# Florida Department of Environmental Protection

June 11, 1993

Re: Hardee County Solid Waste Facility  
Pending Permits: SO25-214306 (Class I Landfill)  
SO25-212896 (C & D Debris)  
WT25-209268 (Waste Tire Site)

# SEQUENCE OF FILL HARDEE COUNTY LANDFILL

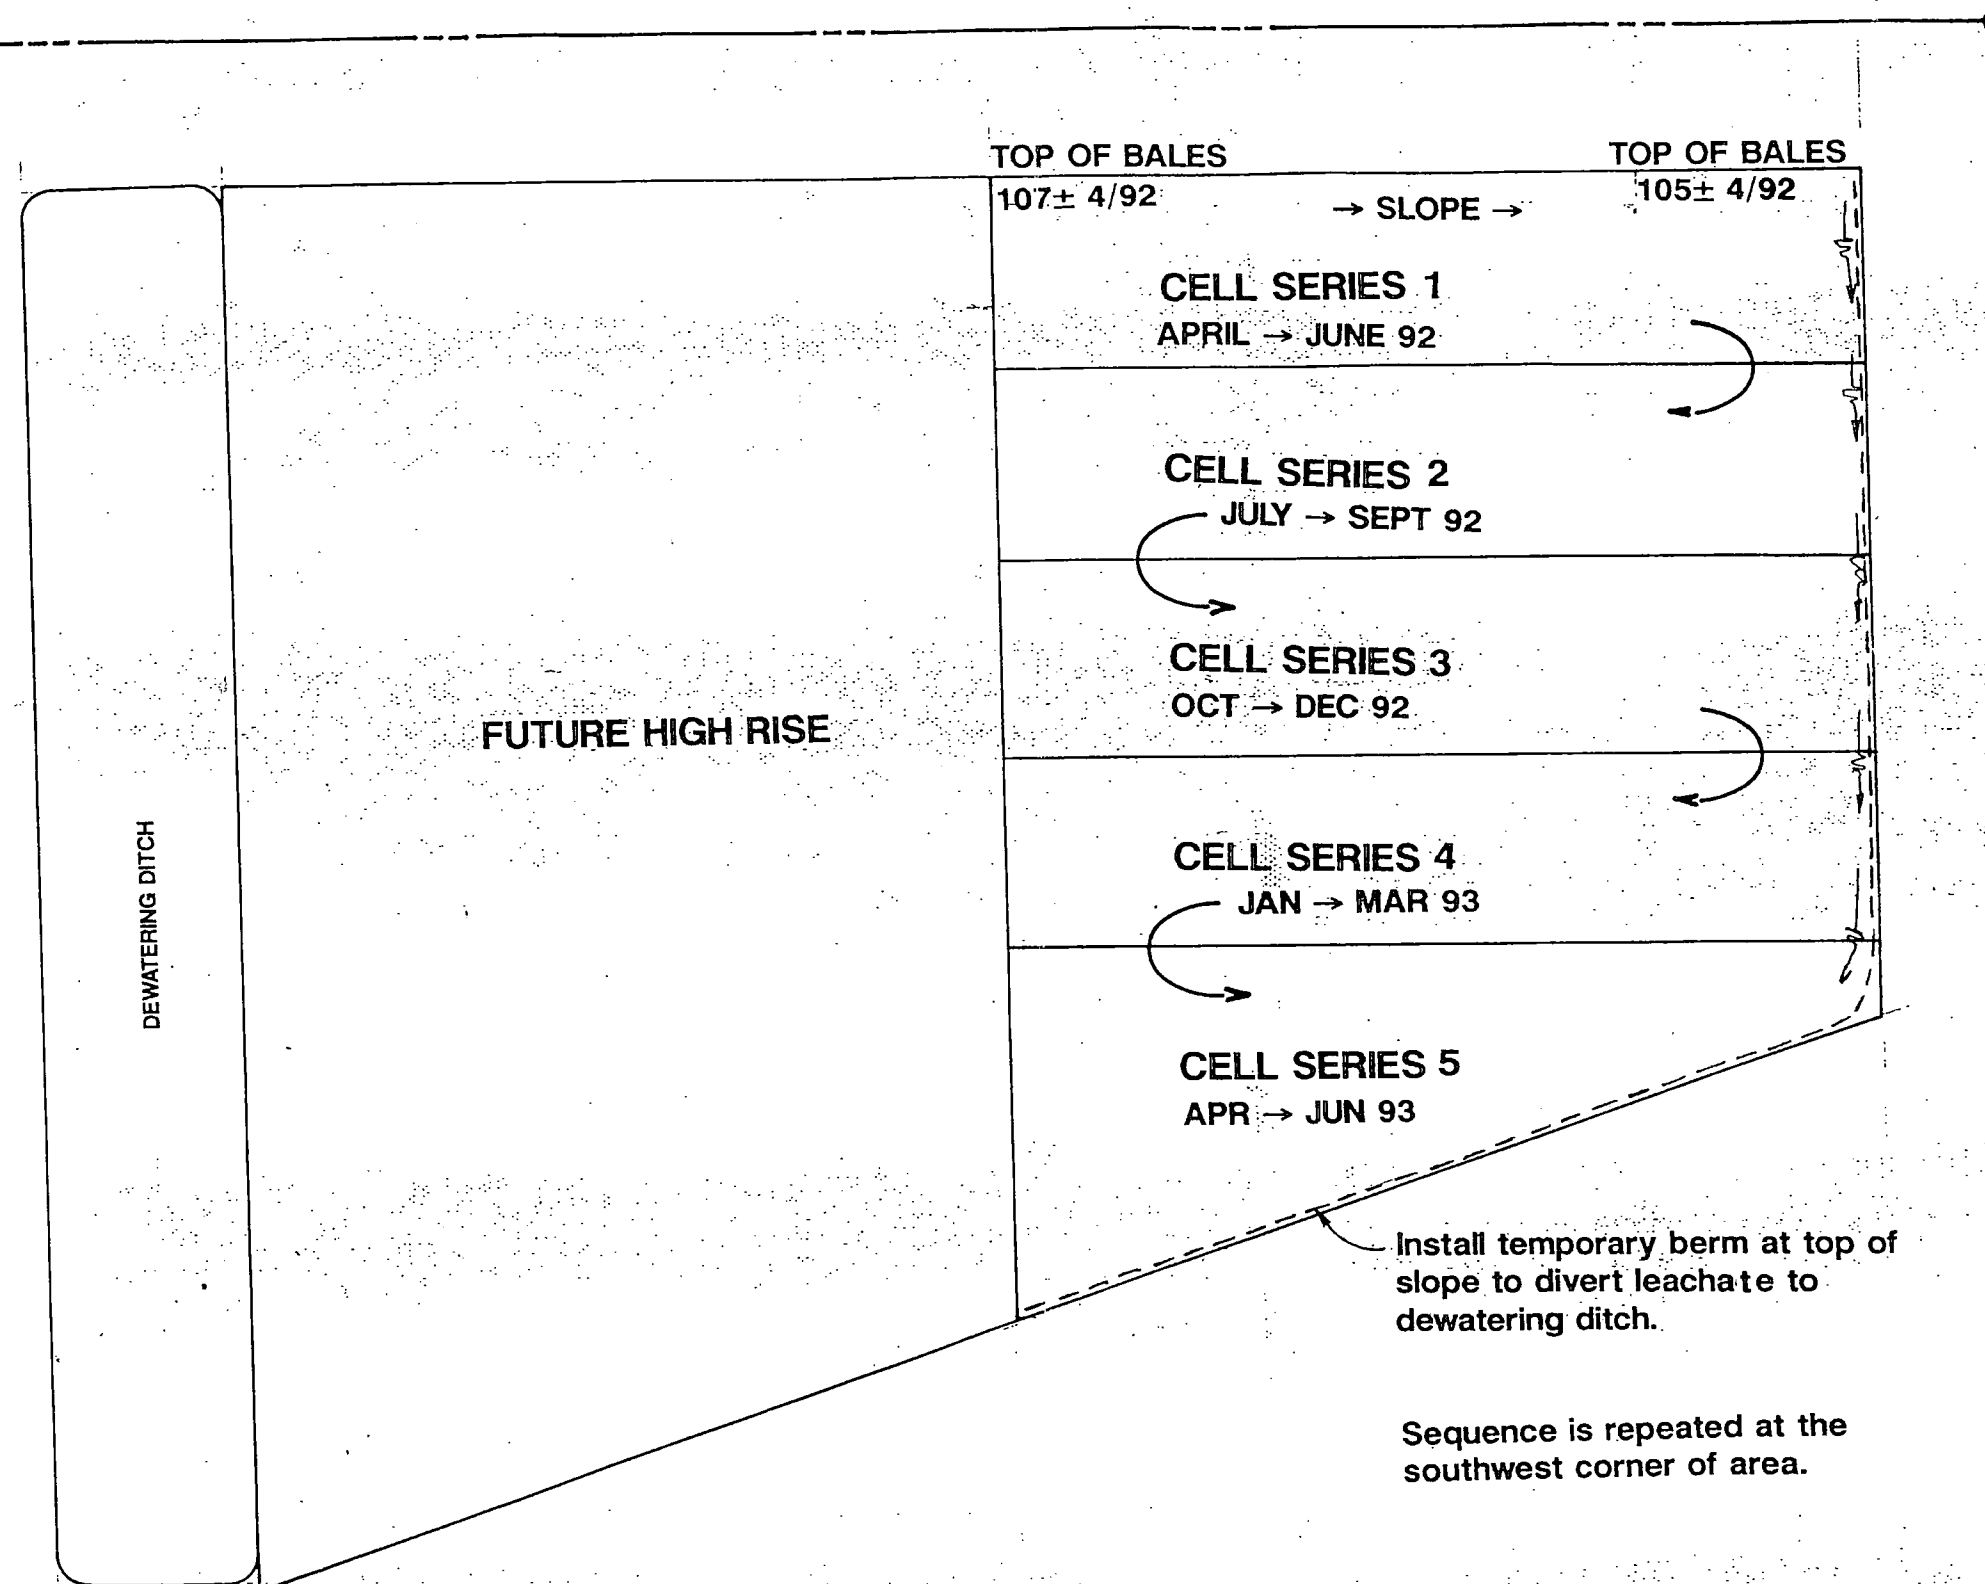
4. The sequence of filling shown on plans is not sufficient. Leachate generation must be minimized, and also prevented from running off active areas into adjacent stormwater system by constructing berms or ditches. Initial or intermediate cover that may receive leachate shall be graded to shed runoff into the leachate collection system and to minimize mixing of leachate runoff and stormwater. Bales shall be stacked to prevent leachate runoff outside disposal area. Provide rationale in support of structural integrity of the landfill side slopes and top final cover utilizing waste bales. Include frequency of cover and cover depth over stacked bales as well as the depth of bales stacked prior to covering. The filling sequence should be clearly described in 3 month increments until such time as the sequence is repeated or the area has reached final contours.

The drawing provided shows an outdated filling sequence and lacks the detail required to properly operate the landfill. Provide plans and cross-sections showing all berms, berm details, access roads and details, side slopes with intermediate cover, and operation schedule for using future high rise area, and schedule for closure. If any areas will be closed within five years, Hardee County should consider developing closing plans. A recent site inspection showed eroded side slopes. Describe measures to correct and prevent future erosion of intermediate cover.

- ✓ 1. No response required
2. Response to Ms. Allison Amram's memo attached
- ✓ 3. No response required
4. Attached is a Revised Sequence of Fill plan. The initial lift is based on an annual solid waste volume of 30,910 cubic yards (including interim cover material). Each lift of cells is constructed with a double layer of bales 5 feet high working across the face of the disposal area. Each designated area is approximately 420 x 100' and capable of holding a volume of 7770 cubic yards. Three months waste volume is approximately 7750 cubic yards. The site is filled beginning in the southwest corner of each lift and proceeding in a northerly direction until the designated area is filled. The filling procedure is then repeated in a southerly direction adjacent to the first area. The procedure continues until the entire layer is filled. When a lift is completed, filling begins again at the southwest corner. The top of each succeeding lift is stepped in 15 feet to maintain a 3 to 1 side slope.

FIGURE 2.- LOCATION OF MONITOR WELLS.

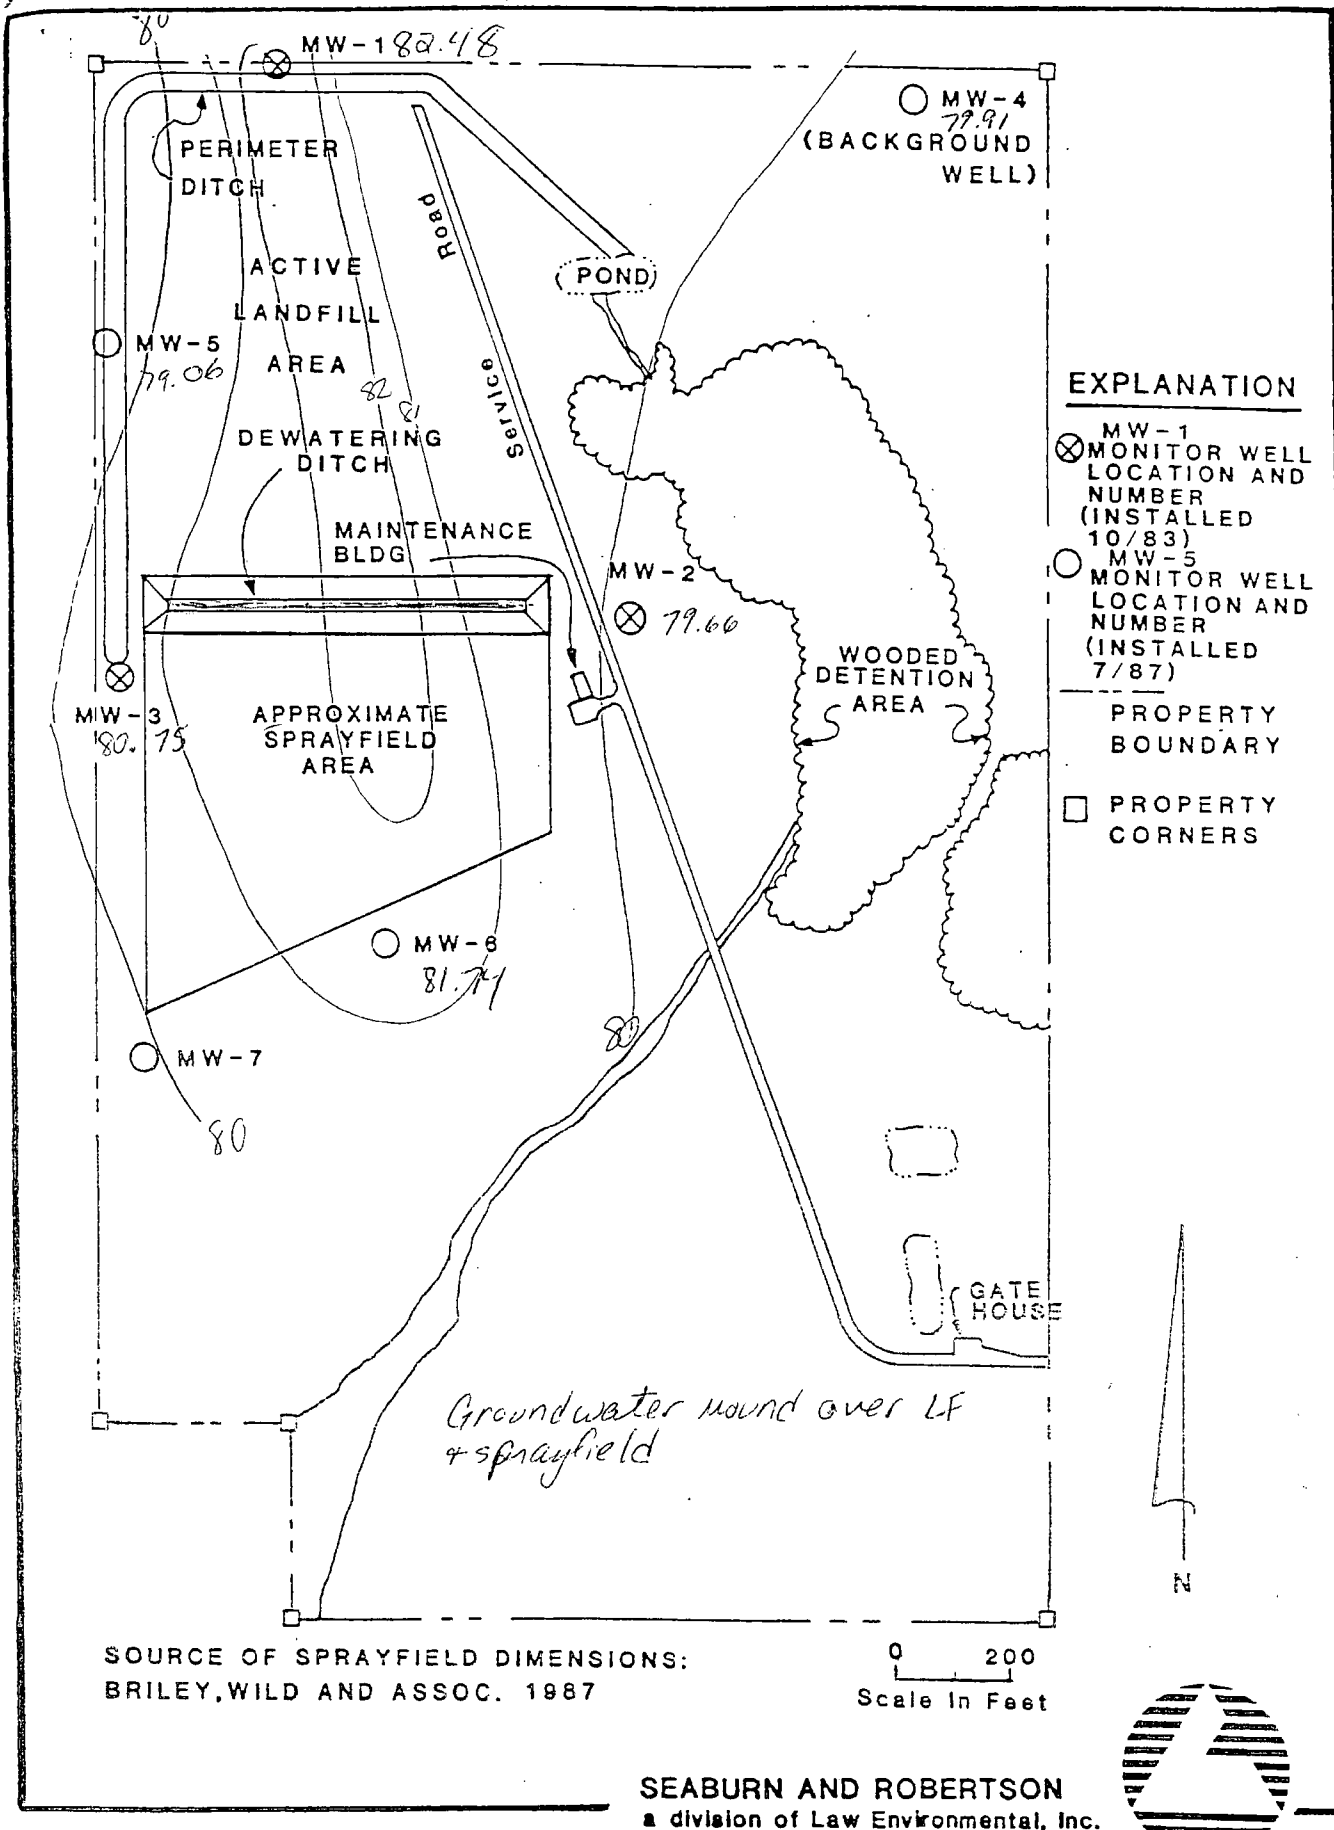
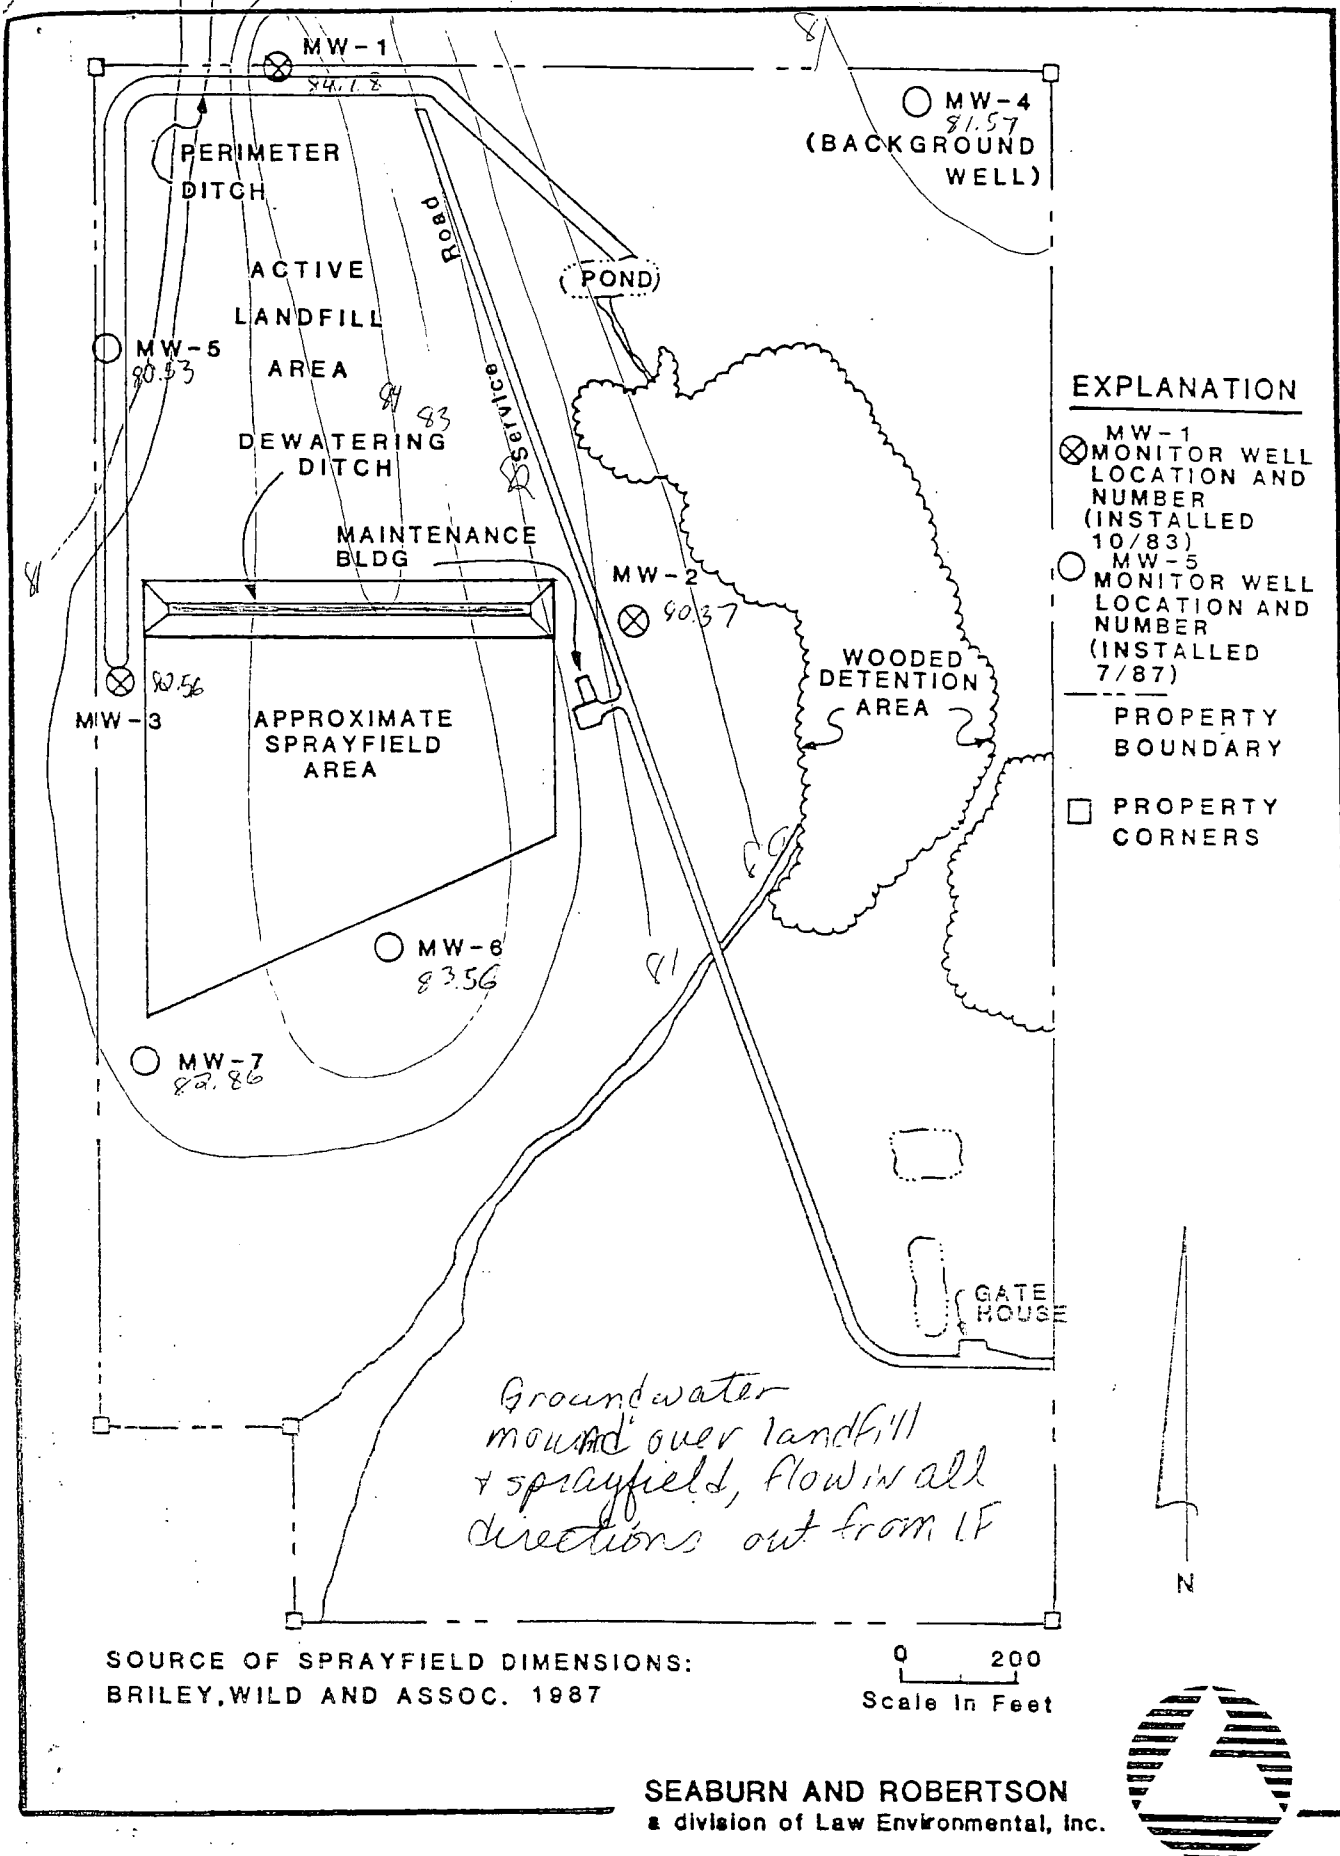
- The Groundwater Monitoring Plan mentions that eight (8) monitoring wells will be monitored, but only seven (7) are present on Plate 4. The Department assumes that these seven monitoring well (MW-1 through MW-7) are all to be monitored in this plan. Is the eighth well the one proposed in the March 1993 submittal to monitor the sprayfield? Please clarify, and provide the location, proposed well construction and purpose of this well.

3. I made up water table maps for 5/92 + 8/92. Both show mounding under the landfill + sprayfield.

### LEACHATE COLLECTION SYSTEM

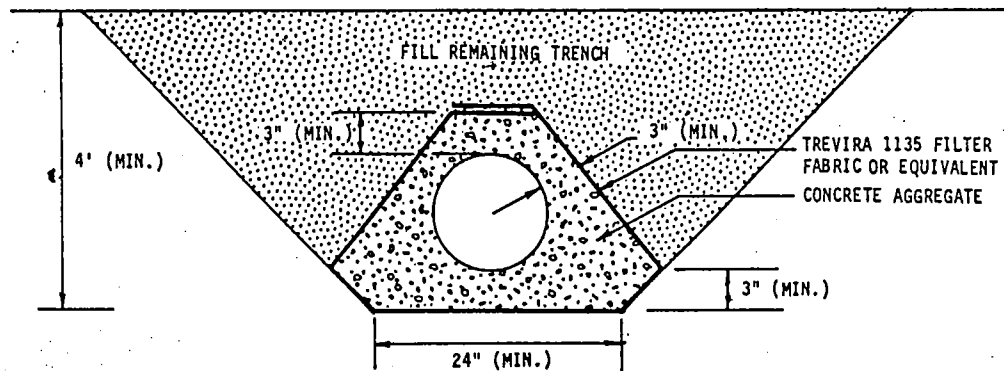
We recommend a peripheral leachate collection underdrain on the west, north and east sides of the landfill. The underdrains should be a minimum of 4 feet below natural ground and should slope toward the dewatering ditch. Figure 6 illustrates two alternative leachate collection underdrain design concepts.

The second alternative consists of a minimum 24-inch wide trench and an 8-inch diameter corrugated slotted HDPE pipe completely surrounded by at least 3 inches of locally available coarse concrete aggregates which in turn is completely wrapped in a filter fabric as shown in Figure 6.
